# Memorandum

**To:** Planning Commission Members  
**CC:** Staff  
**From:** Ann Birch, Community Development Director  
**Date:** 04/13/2007  
**Re:** April 19, 2007 Planning Commission Meeting

**Agenda Item 4B:** An amendment the PUD Plan for Lots 1-3, Southport East Replat Seven, located in Section 18, T-14-N, R-12-E, of the 6<sup>th</sup> P.M., Sarpy County, Nebraska, generally located at Eastport Parkway and Giles Road.

## PUD PLAN

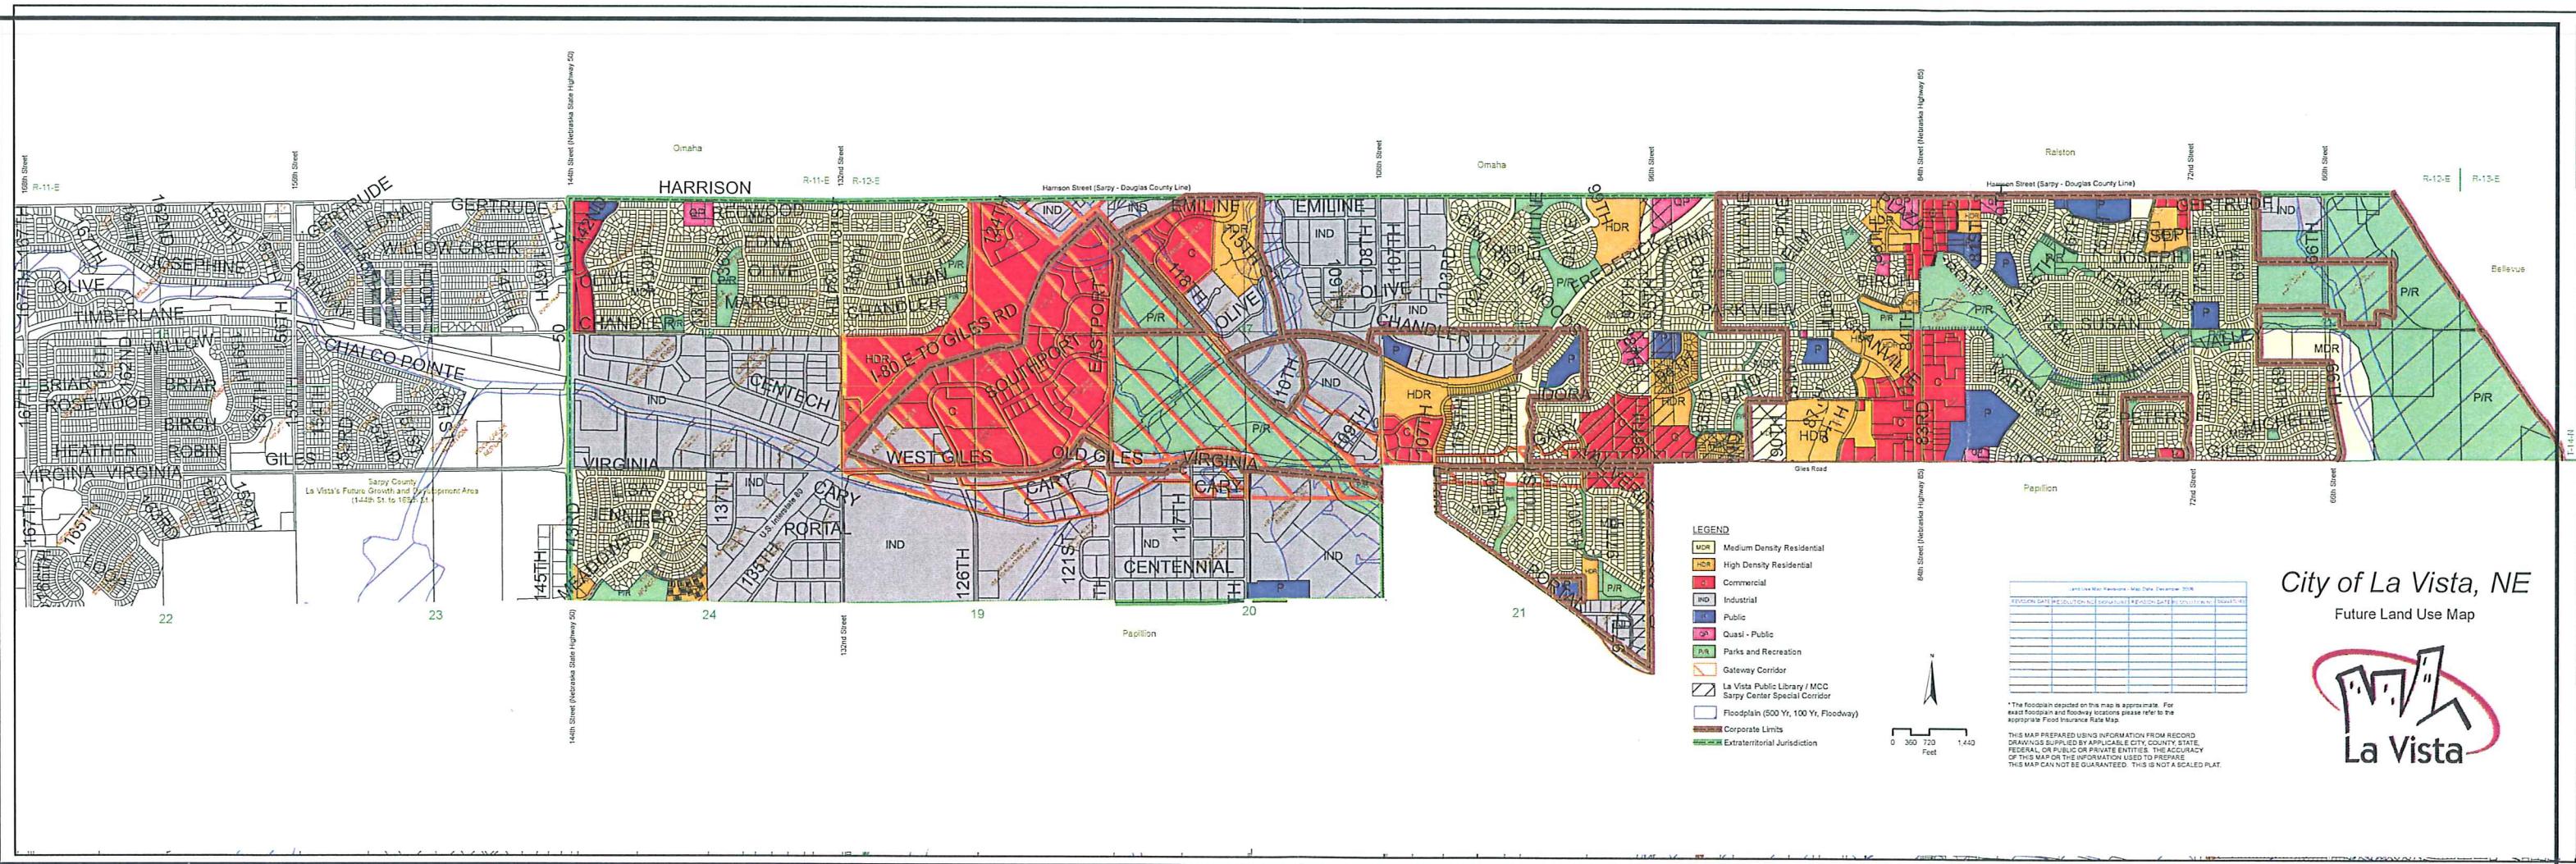
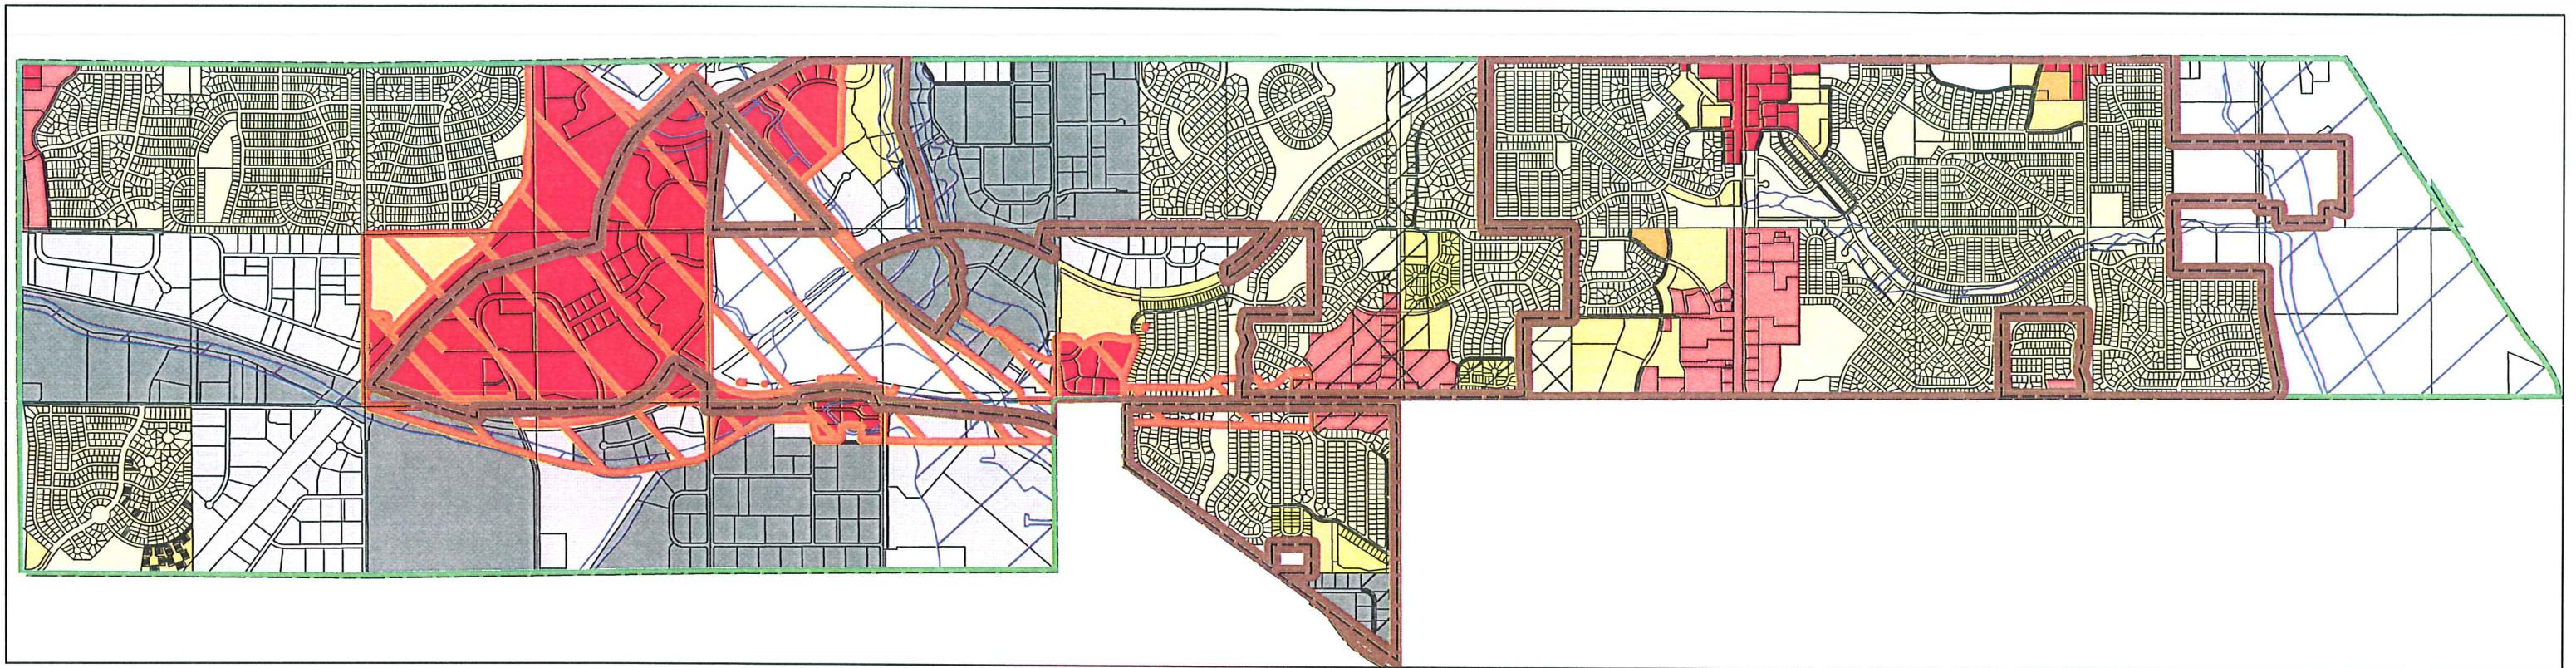
1. All buildings shall have either flat roofs or pitched roofs.
  - a. Flat roofs shall have a slope of less than 1/12. They may be either adhered or ballasted. If adhered the membrane shall be in the lighter color ranges.
  - b. Pitched Roofs shall have a slope of 6/12. They shall be comprised of standing seam metal roofing of a color range that is complimentary to the main body color of the building façade and that is approved by the City.

**Deleted:** the color ranges as shown in Appendix L.
